Arizona Nuclear Power Project

Subject: Final Report - DER 84-62
A 50.55(e) Reportable Condition Relating To Load Sequencer
Did Not Function Properly During Safeguards Testing.
File: 84-019-026; D.4.33.2

FINAL REPORT - DER 84-62
DEFICIENCY EVALUATION 50.55(e)
ARIZONA PUBLIC SERVICE COMPANY (APS)
PVNGS UNITS 1, 2, 3

Figure 1

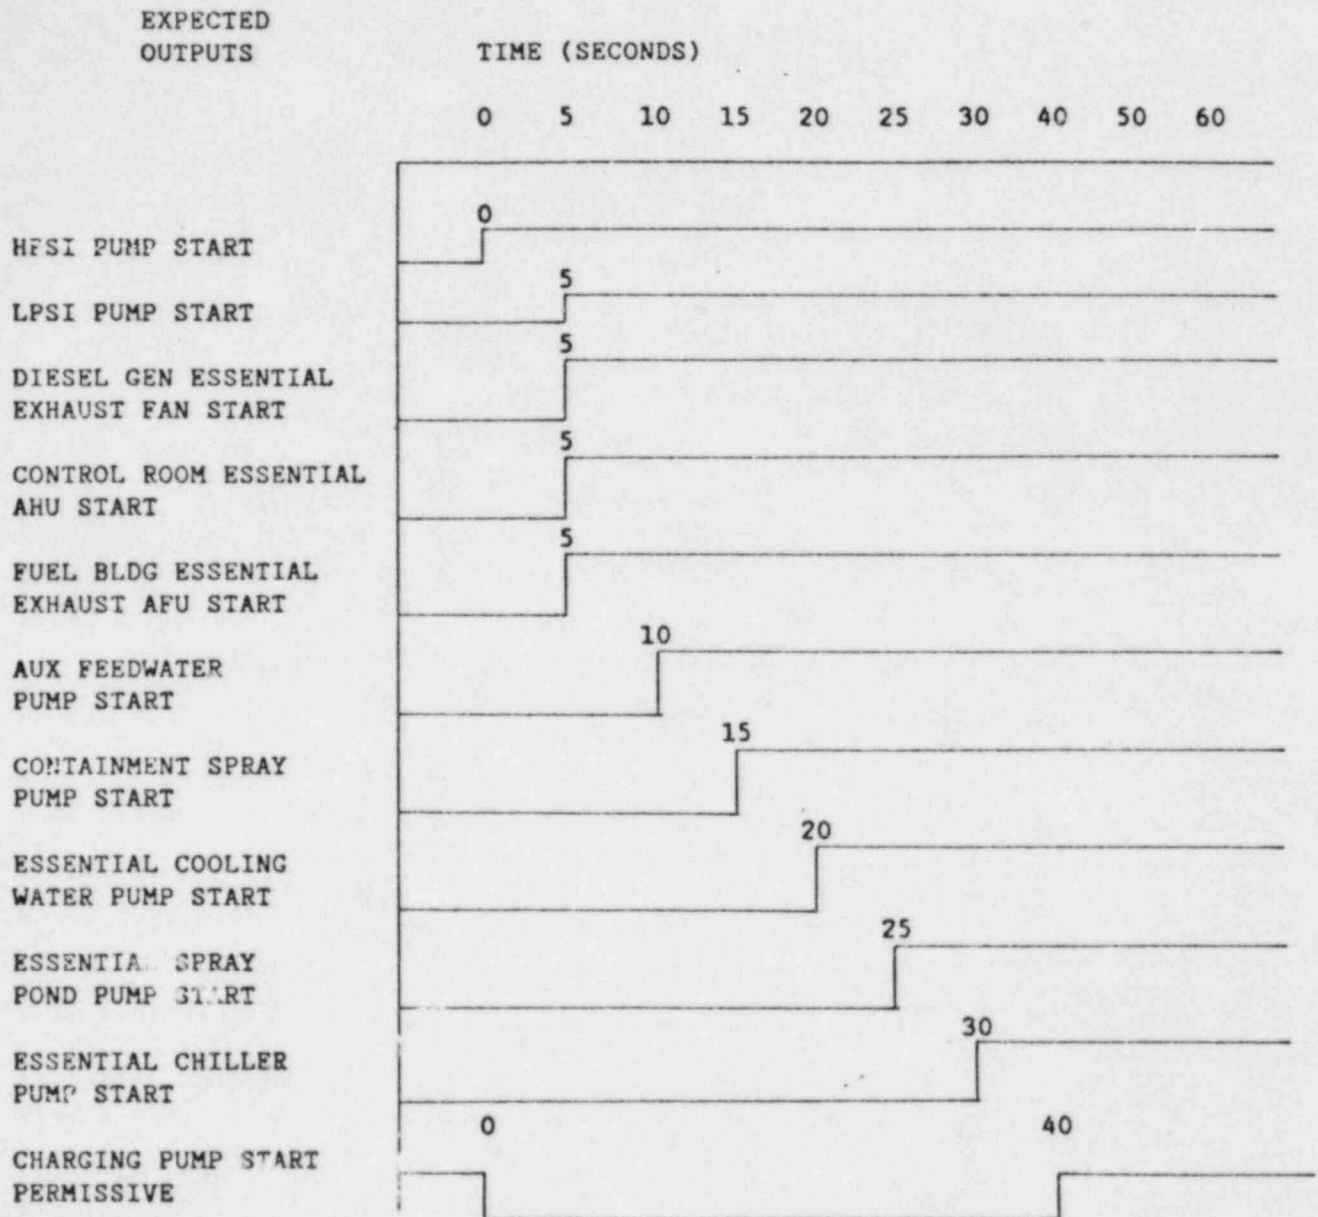
Mode 1 - Safety Injection Actuation Signal (SIAS) without Loss of Power (LOP). See Figure 1 for timing sequence.

In Mode 1, the Diesel Generator (D/G) is running with its breaker open and ready to close if off-site power is lost. Upon receipt of a LOP signal, the Diesel Generator breaker closes. This closure shifts the BOP ESFAS sequencer to Mode 2. The shift to Mode 2 causes the 480V Load Center (LC) main breakers and the High Pressure Safety Injection (HPSI) pump breaker to close 0.5 seconds later. However, the LOP event independently triggers a load shed signal of 1 second duration which keeps the LC and HPSI breakers open even though they receive a close signal 0.5 seconds after LOP occurs. These simultaneous "open" and "close" commands to the LC and HPSI breakers cause their anti-pump circuits to "lockout," thereby deenergizing the LC and preventing the HPSI pump from starting as required.

Figure 2A

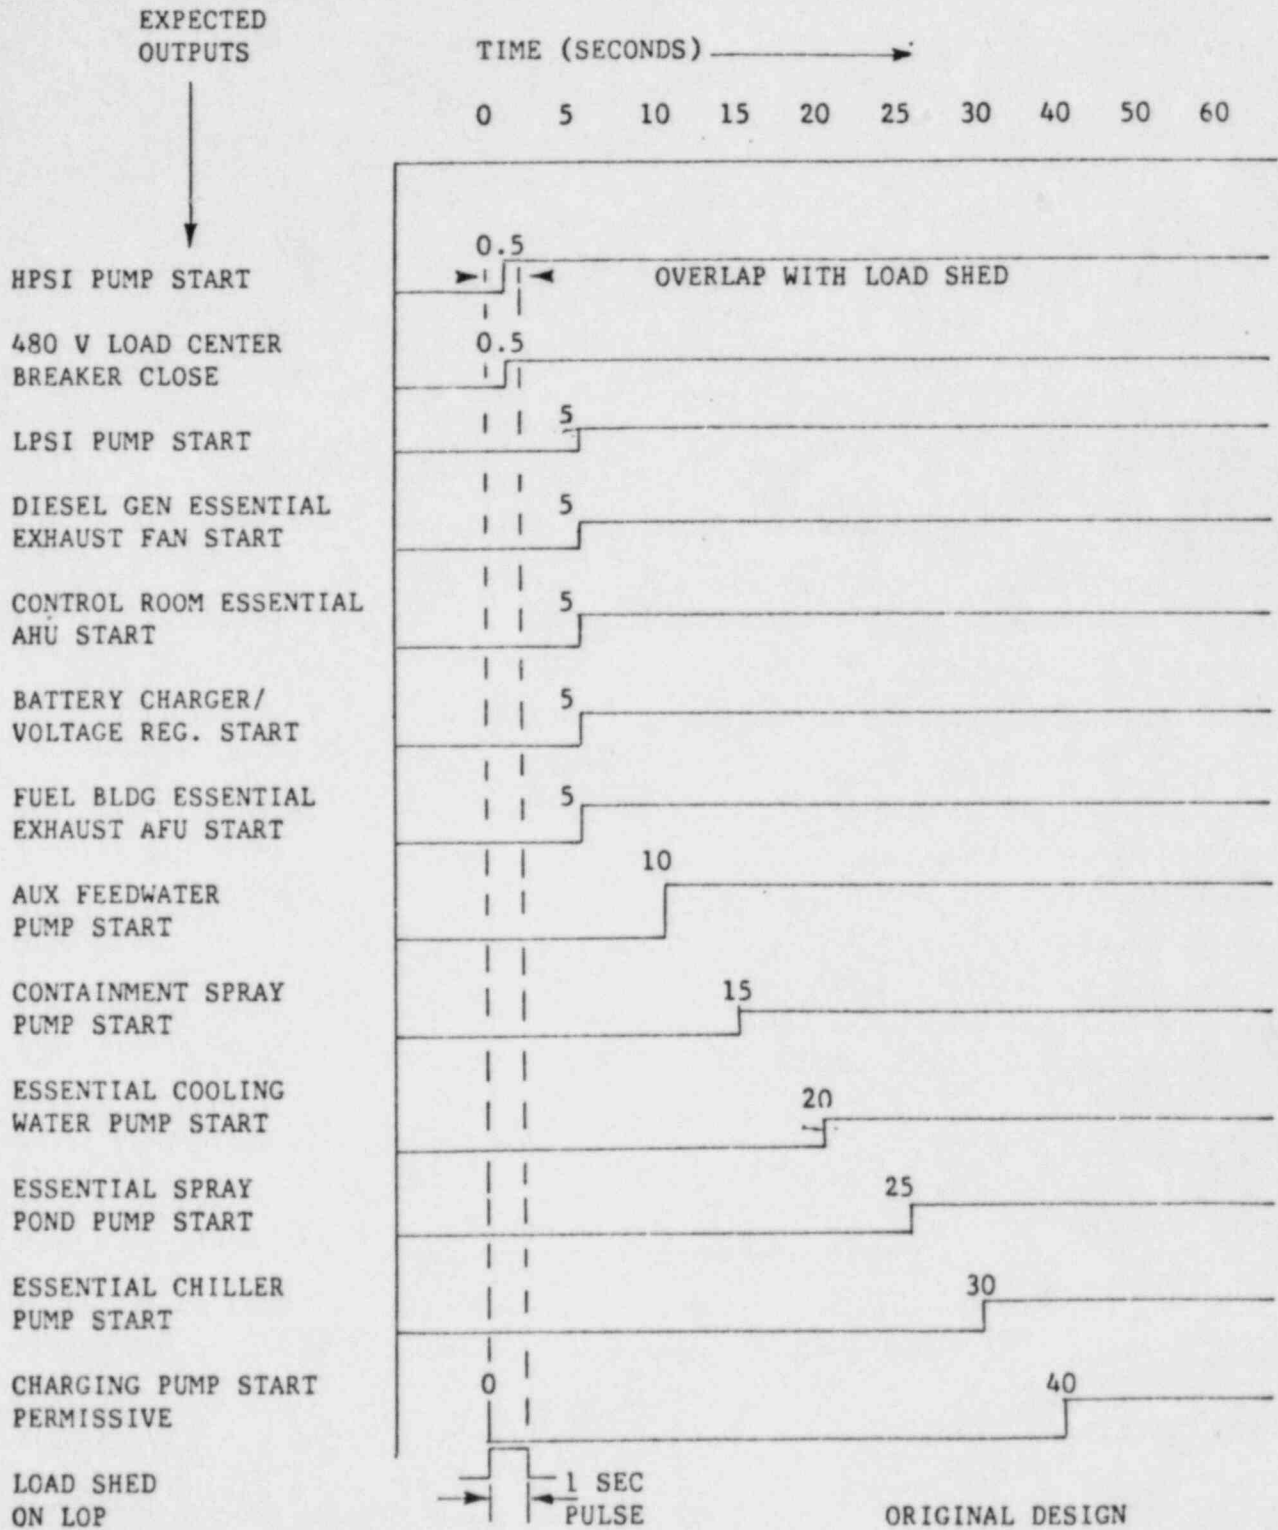
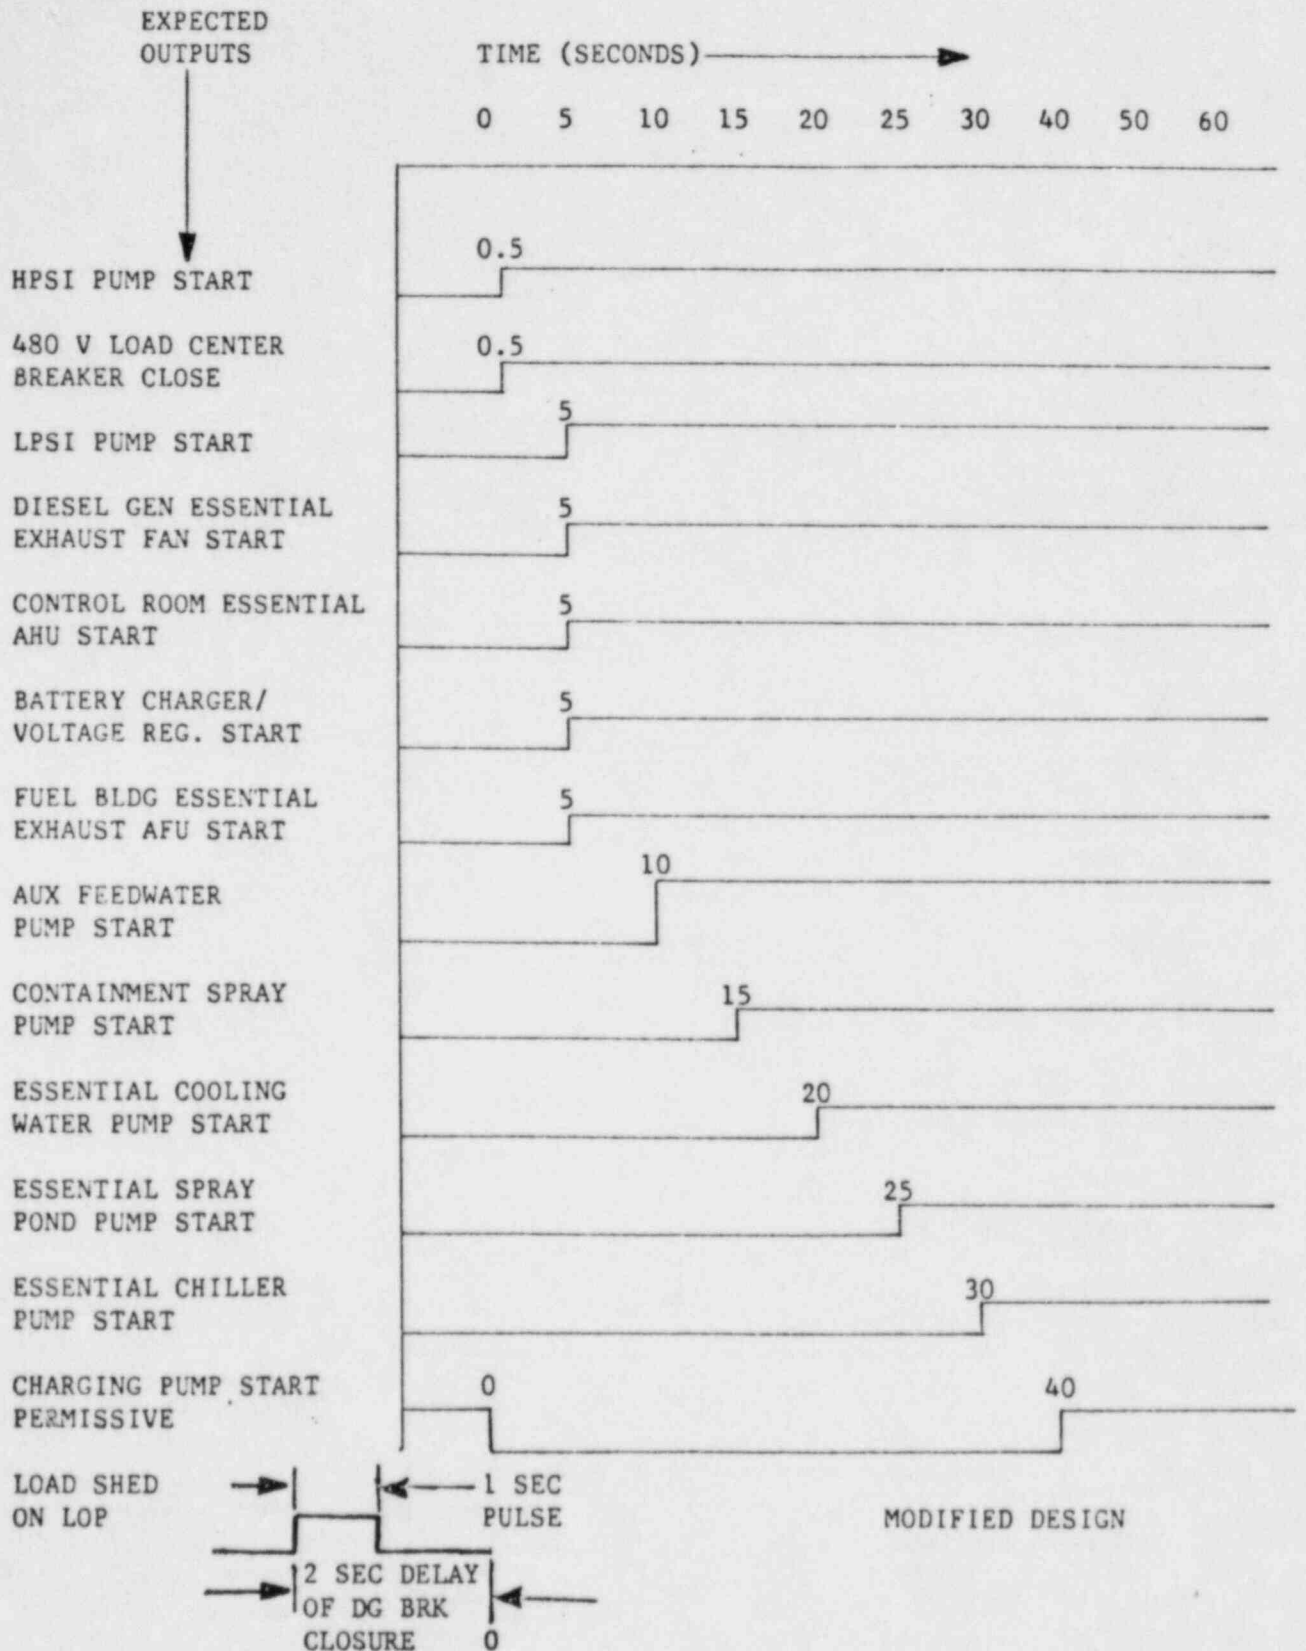
Mode 2 - SIAS with LOP. See Figure 2A for timing sequence.

Analysis of the recorder graphics taken during the pre-operational tests confirmed that the HPSI pump breaker did not close because it had locked into an anti-pump mode due to the presence of the simultaneous load shed (open) and start (close) signals.

In regards to the 480 volt center, the recorded data showed that its breaker did not close for the same reasons listed above; i.e., simultaneous open and close signals to its breaker which caused it to lock out. However, it was further noted that the breaker's closing spring charging motor requires a period of 2 to 5 seconds to re-charge after a trip (open circuit breaker) before it is capable of closing the breaker again.

The simultaneous "open" and "close" signals to the HPSI pump breaker were eliminated by delaying for 2 seconds the closing of the D.G. Breaker after a loss of offsite power following a SIAS. Since closing of the D.G. Breaker shifts the BOP ESFAS sequencer from Mode 1 to Mode 2, the entire sequence of contact closures for Mode 2 is also delayed by 2 seconds. Thus, since the LOP event independently triggers an immediate load shed signal of 1 second duration, the open and close signals are now totally separated by $2 - 1 = 1$ second. This separation is schematically shown on Figure 2B. To accomplish this 2-second delay, two redundant Class 1E Agastat relays were connected in a "one-out-of-two" logic circuit which actuates the "close" circuit of the diesel generator circuit breaker. These relays are simultaneously energized on loss of offsite power and their respective contacts close in 2 seconds.

The problem regarding the simultaneous "start" and "stop" signal to the 480 volt load center breaker has been solved in the same manner as described above for the HPSI pump. Furthermore, the 2-5 second delay required by the 480 volt load center's breaker closing spring charging motor has been totally eliminated. This was accomplished by bypassing an interlock so that the breaker's closing spring will be recharged after the breaker is closed, instead of after it is opened, as it had been originally connected. Thus, the breaker will be ready to close immediately (without the 2-5 second delay) upon lifting of the load shed signal.

The simultaneous "open" and "close" signals to the HPSI pump breaker will be eliminated by adding an interlock to the HPSI pump circuit that does not allow the start signal from the BOP ESFAS sequencer to be applied to the HPSI pump breaker until after the load shed trip signal has disappeared/cleared.

The simultaneous "open" and "close" signals to the 480 volt load center breaker will be eliminated by deleting the load shed signal ("open" signal) after a loss of off-site power to this breaker. Thus the load center breaker will be continuously tied to the Engineered Safety Features (ESF) bus. It has been verified that this load will not degrade the operability of the diesel generator.
